Loma Prieta Chapter: San Mateo, Santa Clara & San Benito Counties

Darryl Boyd, Principal Planner  
City of San Jose  
San Jose, CA

June 29, 2007

**Figure 1-18: Coyote Creek and Fisher Creek Discharge at Narrows Confluence**

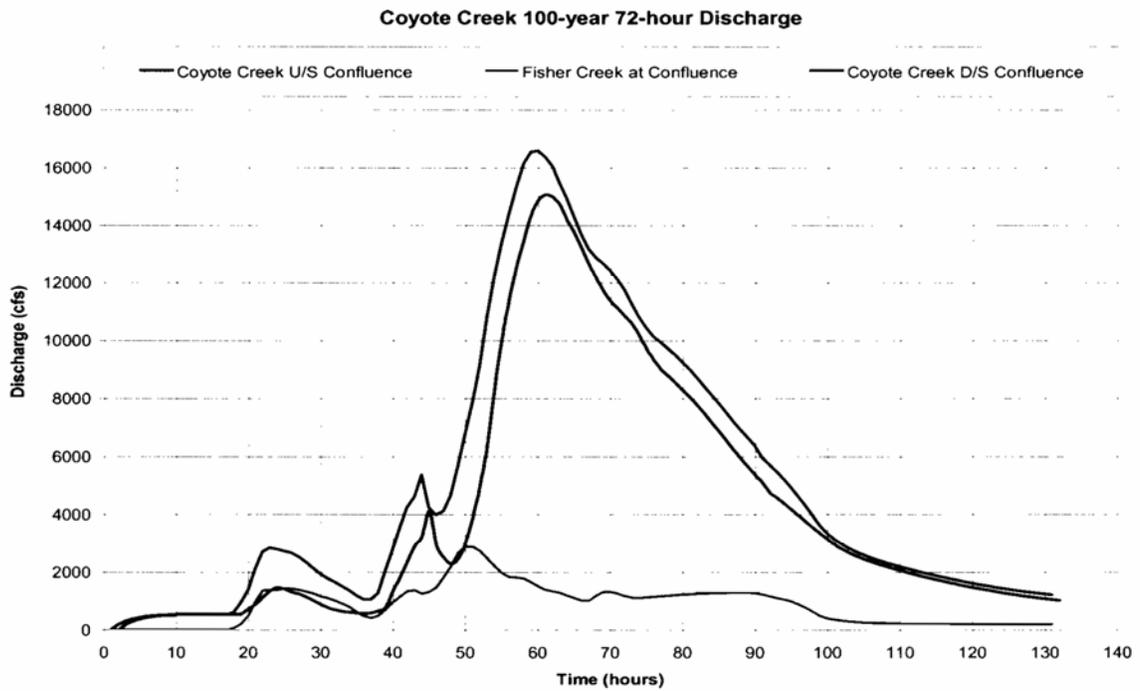
Figure 1-18 also demonstrates that although the first significant peak of Coyote Creek’s design hydrograph nearly coincides with Fisher Creek’s peak discharge, the second (and larger) Coyote peak occurs as Fisher Creek is within its recession. This phenomenon is due to the relative size of the two watersheds and reservoir attenuation on Coyote Creek.

Figure 2-8: Impact of CVSP on Coyote Creek Hydrograph Downstream of Fisher Creek

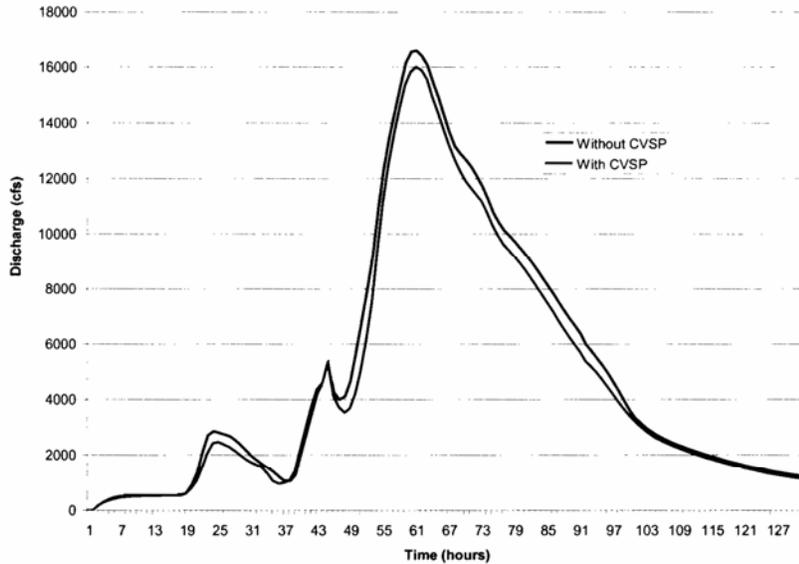
Table 2-6 lists predicted 100-year discharges for Coyote Creek at William Street with (“Post”) and without (“Exist”) CVSP development. William Street is located at the creek’s historic bottleneck and is the point of initial flooding between Fisher Creek and San Francisco Bay (Figure 2-9). Its bank-full capacity has been estimated to be approximately 9,500 cfs, noting that an upstream capacity of roughly 14,700 cfs downstream of Edenvale limits the discharge of water in the creek channel. Because the initial storage in Anderson Reservoir plays a significant role in the magnitude of downstream flooding, a range of antecedent pool storage has been analyzed, with 81,000 acre-feet representing the modeled 100-year condition (per SCVWD).

**Figure D-2: Groundwater Management in Coyote Sub-basin**

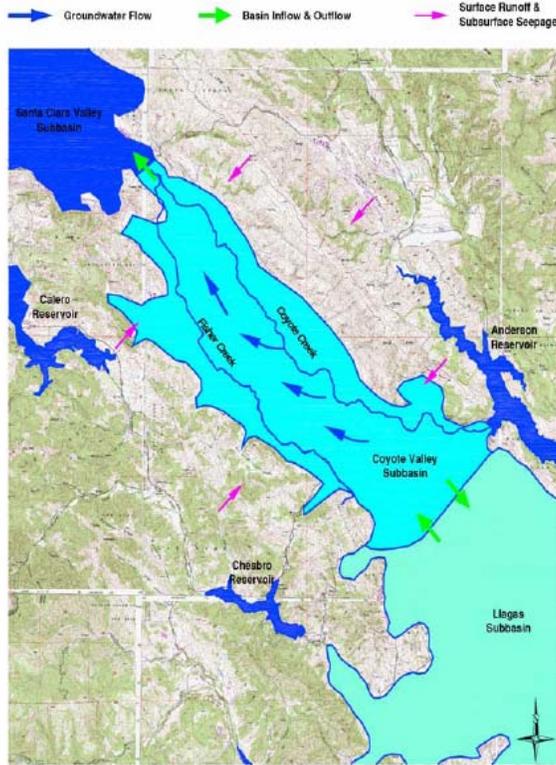
The Coyote Canal is located to the east of Coyote Creek and parallels Highway 101. This facility was built to help manage water resources in the valley, and in particular to deliver water around Coyote Creek’s recharge area between Highway 101 and the Coyote Creek Golf Course because this recharge historically caused high groundwater levels in Coyote Valley. The Coyote Canal has historically been a tool to manage groundwater in Coyote Valley and prevent the loss of water supplies upstream of the Metcalf Percolation Ponds and the Santa Clara Sub-basin aquifer it recharges.

Figure D-7: Avg. Depth to Groundwater in Fall

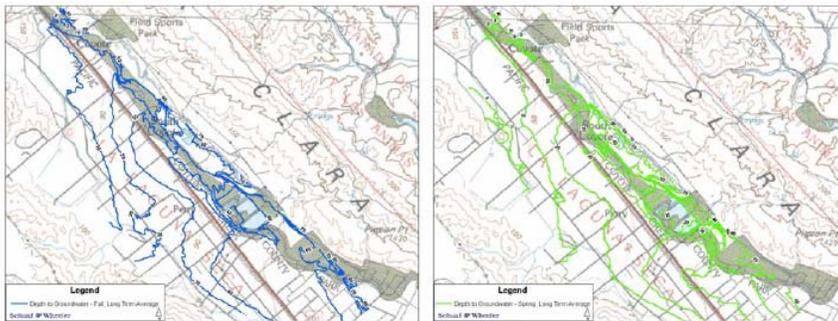
Figures D-7 and D-8 show, respectively, the long-term average depth to groundwater (as measured in feet from the ground surface) during the fall and spring. Both fall and spring groundwater tables become shallower toward the Narrows. Note also that the long term average spring condition shows groundwater at the surface (depth 0) in Laguna Seca at the north end of Coyote Valley.
